Service Bulletin

Bulletin No.: 18-NA-021

Subject: Premature Rear Tire Wear on Inside Edge

Brand:	Model:	Model Year:		VIN:		Engine:	Transmission:
		from	to	from	to		
Buick	Cascada	2016	2018

4896062

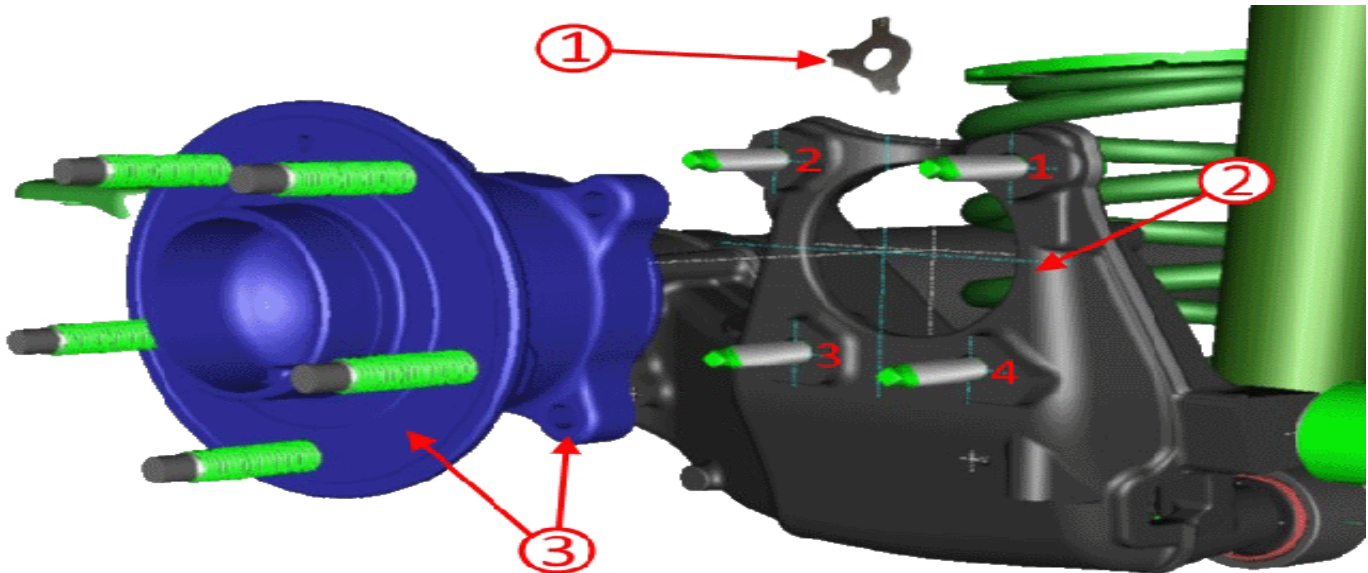
1. Install the alignment equipment according to the manufacturer's instructions.
2. Jounce the front and rear bumpers three times prior to checking the wheel alignment.
3. Measure the rear alignment angles and record the readings.
4. Access the worksheet located in the "Service Forms" application of GlobalConnect.

5. Enter recorded values to determine which shims to use in alignment correction.
6. Record shim part numbers and locations.
